Approved Drainage Proposal and Approval Letter for Partial Compliance with
Approval Condition of Last Application No. A/SK-PK/268

**Drainage Design Report for
Proposed Temporary
Private Swimming Pool and Garden for
a Period of 3 Years at
Lot 1122 Ext and Adjoining Government Land in D.D. 217,
House 5B, Habitat, Pak Sha Wan,
Sai Kung, New Territories
(2nd Resubmission)**

*Philip So & Associates Consulting Civil & Geotechnical Engineers Ltd.
August 2024*

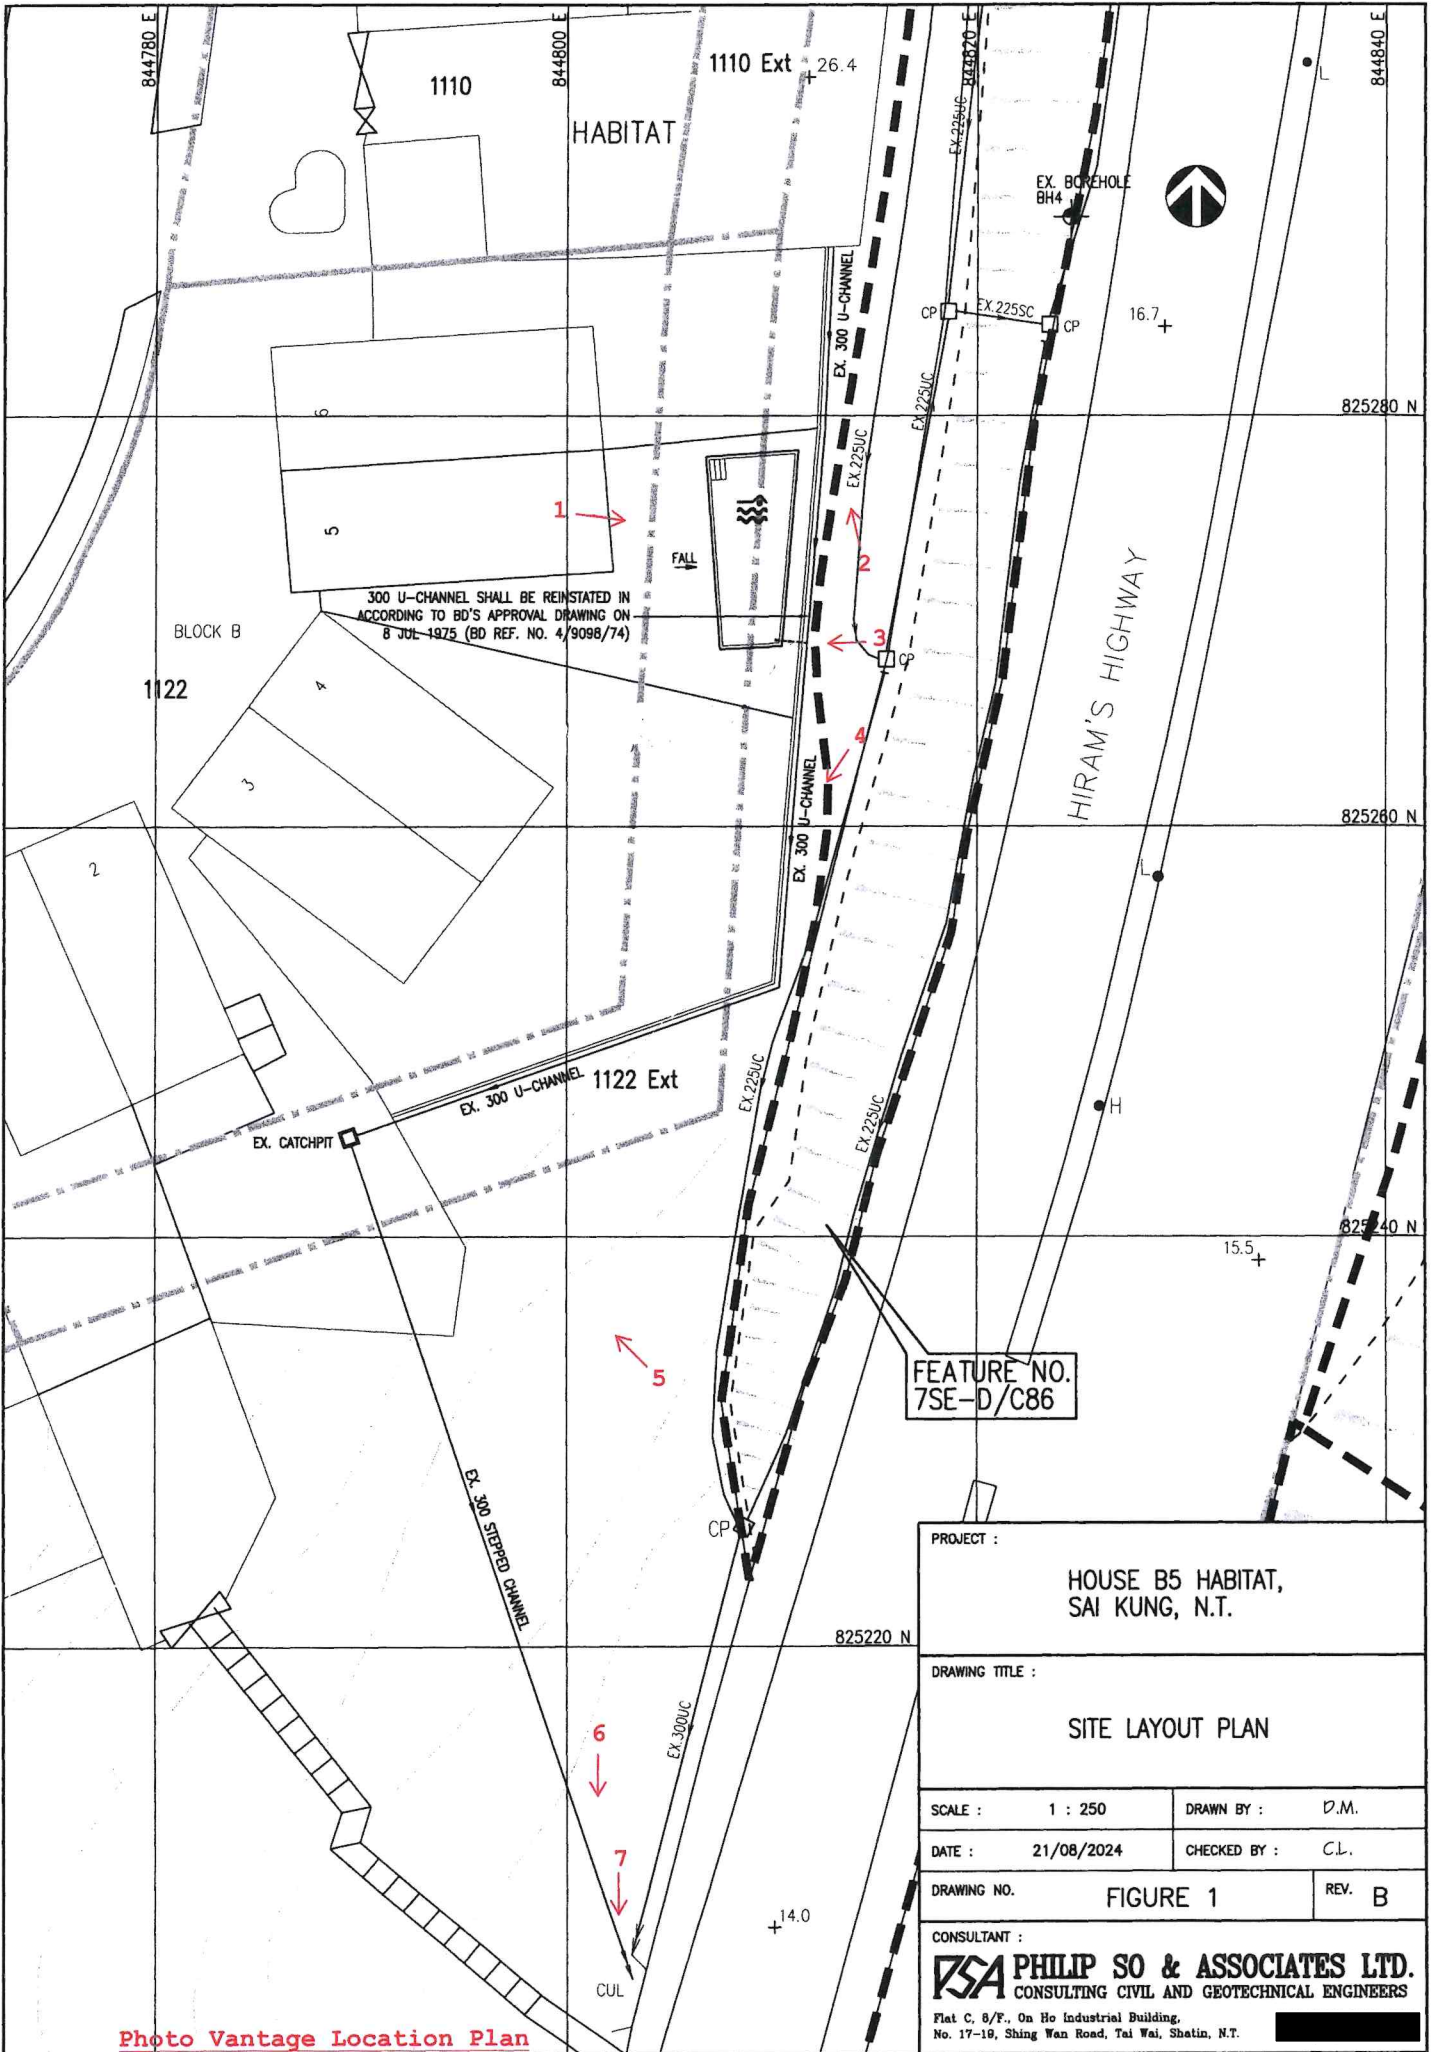
5) Please supplement site photos showing the current conditions of the existing 300mm U-channels and stepped U-channel as well as the associated catchpits for our consideration.	Site photos indicate that the existing u-channels and the associated catchpits are blocked and covered by dense vegetation. Dense vegetation shall be removed, and the u-channels and the associated catchpit shall be unblocked. Repair works for the drainage network shall be carried out by the lot owners if deterioration found.

Site inspection reveals that the existing u-channels and catchpits situated along the existing wall toe of House B5 are blocked and covered by dense vegetation. The layout of the drains match with the drainage plan approved by Buildings Department on 8 July 1975 with BD Ref No.: 4/9098/74. The approval drawing is attached in Appendix B.

The concerned u-channels and the associated catchpits shall be unblocked. Repair works for the drainage network shall be carried out if deterioration found.

BLOCK PLAN 1/16"=1'-0"
PROPOSED APARTMENT HOUSES ON D.D. 217
LOT 1122 PAK SHA WAN, N.T.

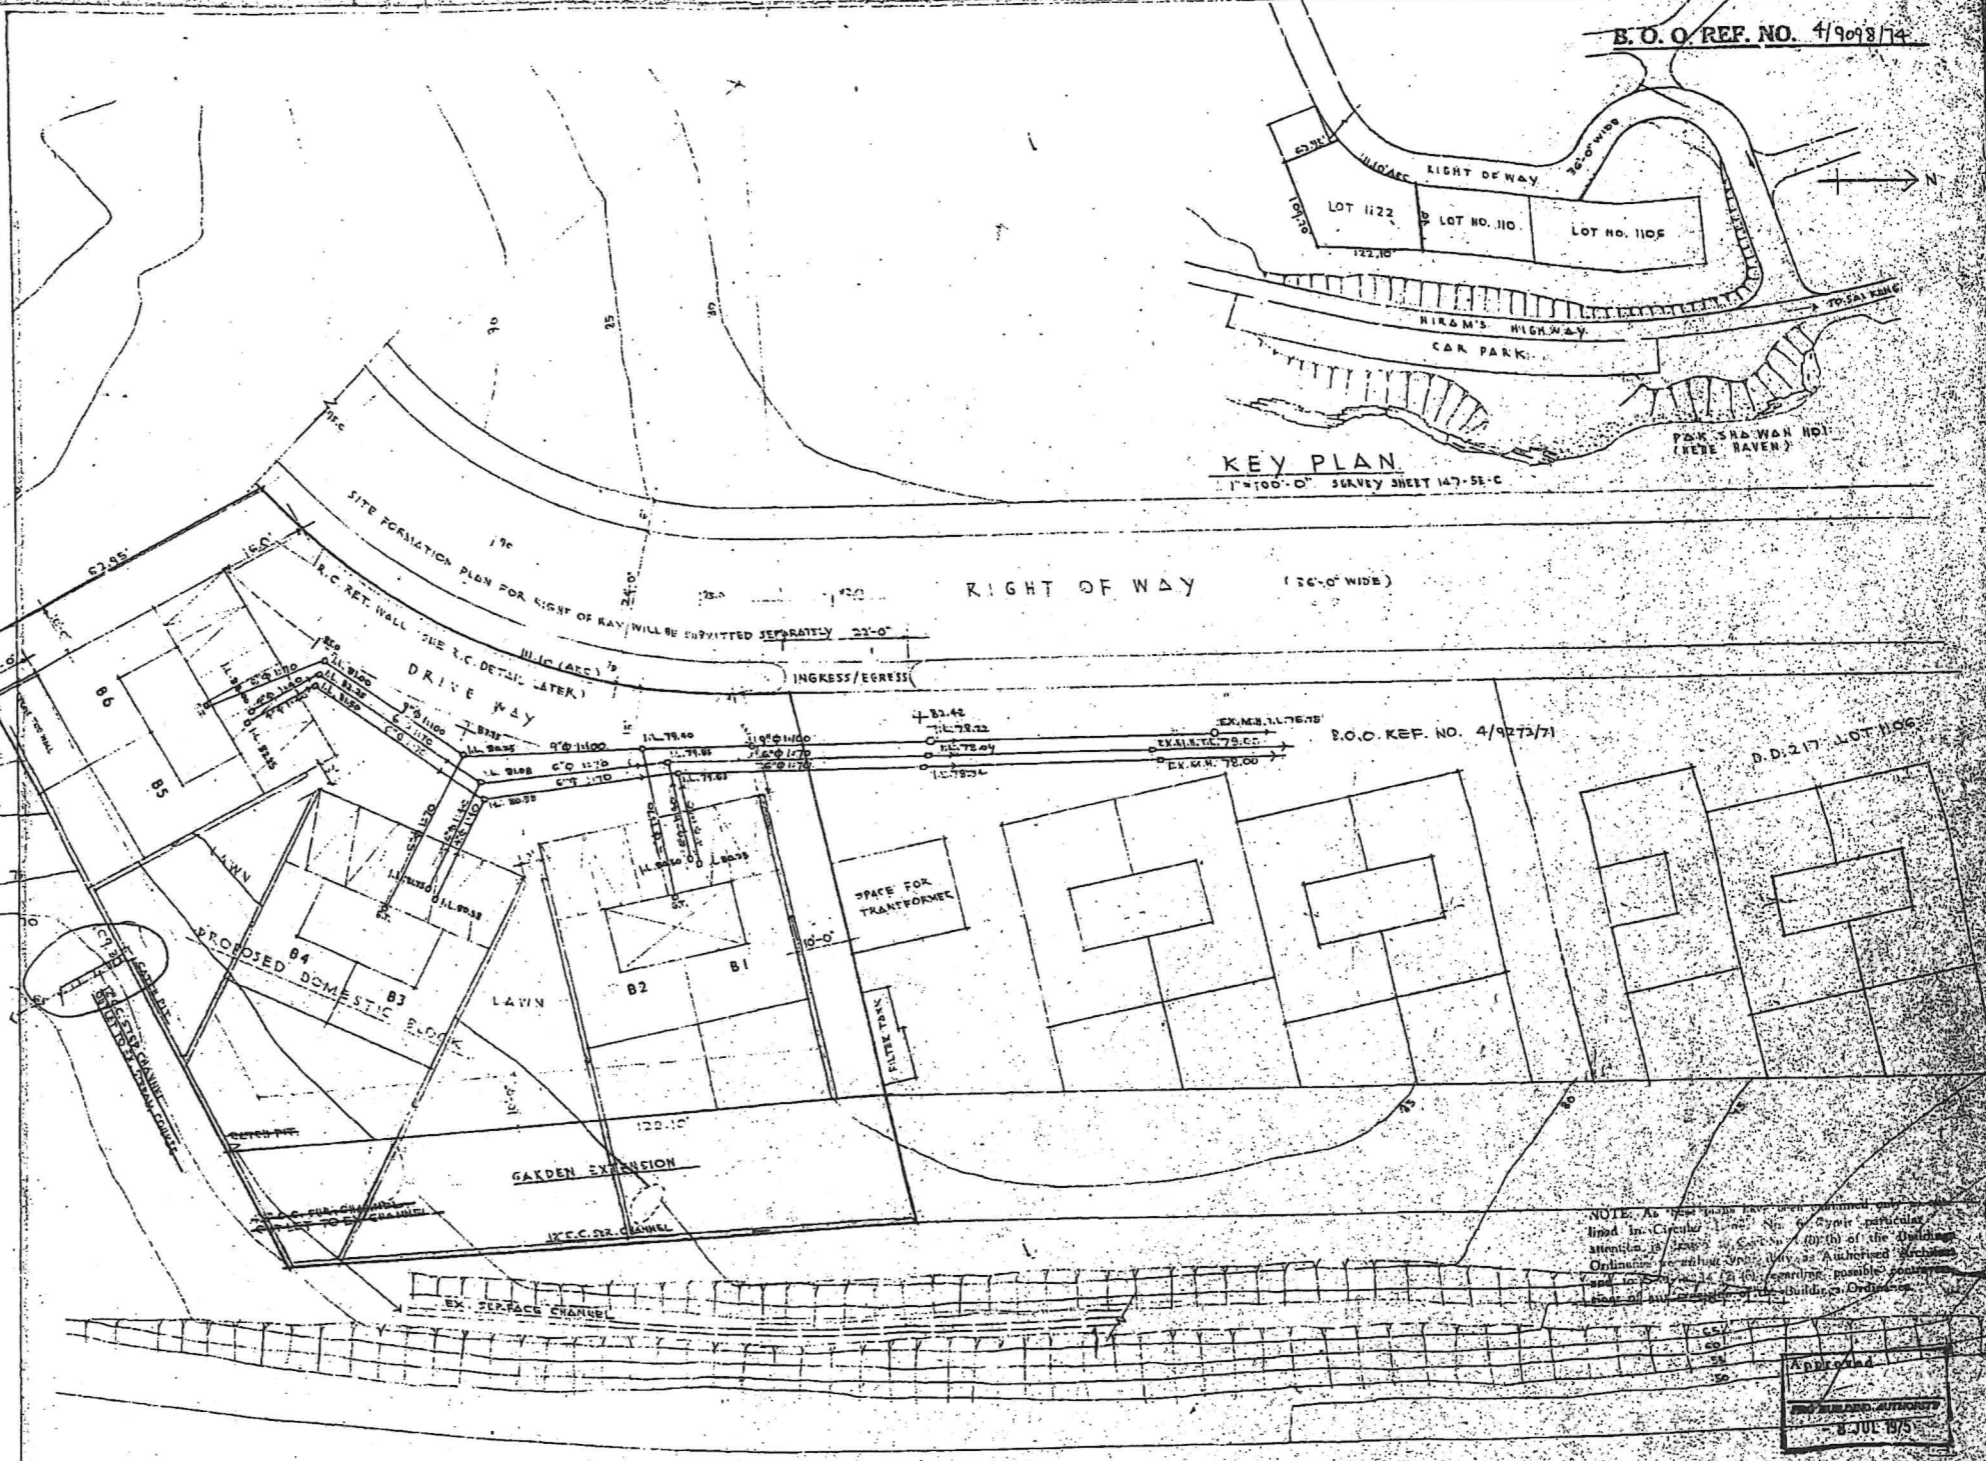
<p>2) According to the part print of the Buildings Department's approval drawing dated 8 July 1975, it appears that there is no swimming pool mentioned in the drawing. As such, we consider that the existing drainage system was not intended to deal with the discharge of the pool water at the time of approval. In view of additional flow being discharged to the existing drainage system, please critically review, with the supporting document, whether the existing drainage system is capable of dealing with the surface runoff/pool water being discharged from the proposed development.</p>	<p>Ditto.</p> <p>In addition, discharge from the $\phi 50$ over flow pipe has been considered in the drainage checking.</p>
